# Behaviour without FEC

# Behaviour with FEC

# Compromise Solution

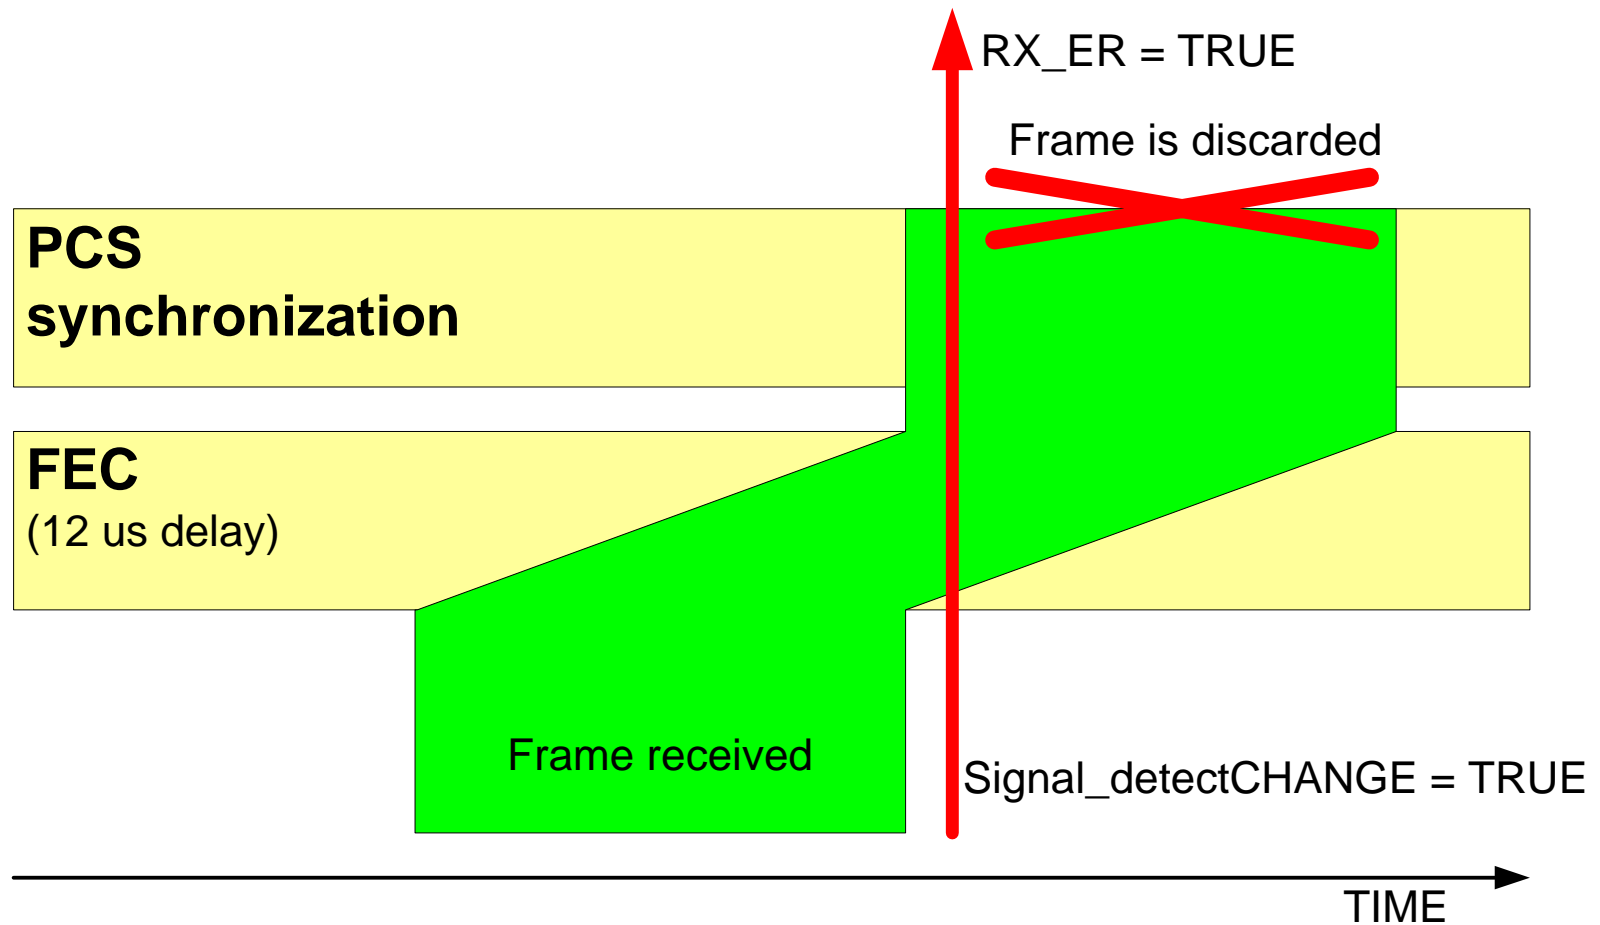
- FEC parity octets are appended at the end of a frame. Last byte must be received before the first byte passed to PCS
- Lost signal after burst end kills previous frame

# So what if frames are lost?

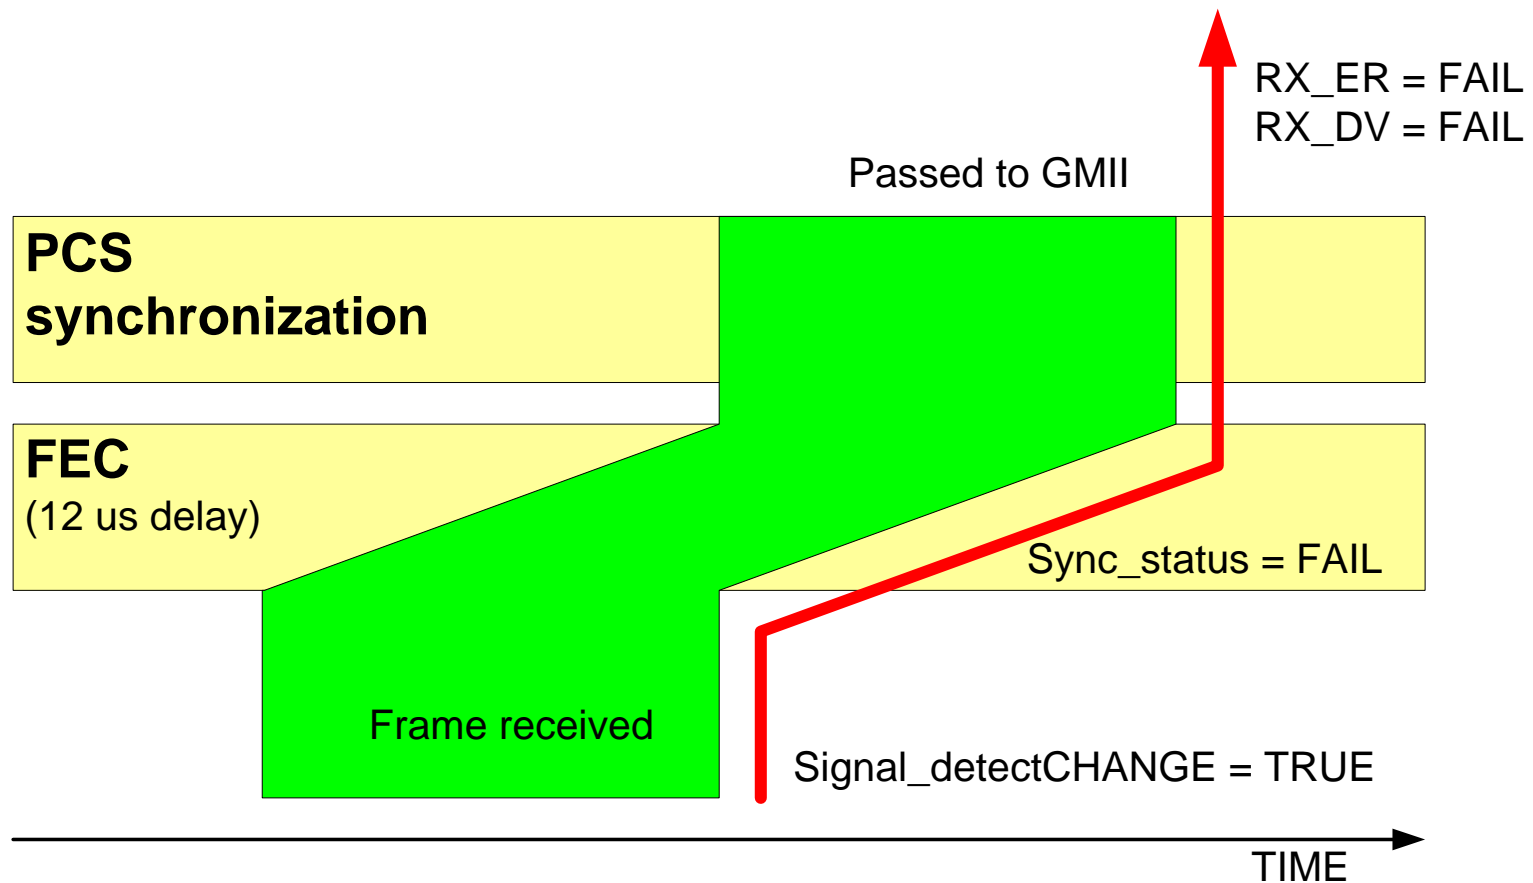
- OLT loses sync between ONU bursts (normal condition)
- Each burst from each ONU will lose up to 1518 bytes (1 to 18 frames)
- Back-of-envelope calculation:
  - 16 ONUs, 1 ms cycle
  - Up to 1518 bytes per burst are always lost, 1518 x 16 bytes are lost per cycle
  - **BER after FEC = 19%**

- d) Support BER objective of  $10^{-12}$  at PCS (cannot be met);
- e) Support BER objective of  $10^{-4}$  at FEC sublayer.

- NOTE: To ensure correct MPCP operation, FEC function must maintain constant and equal delay for all code-groups and all signals transmitted from PMA to PCS. Timing effects of adding FEC function should be indistinguishable from an increased propagation delay.
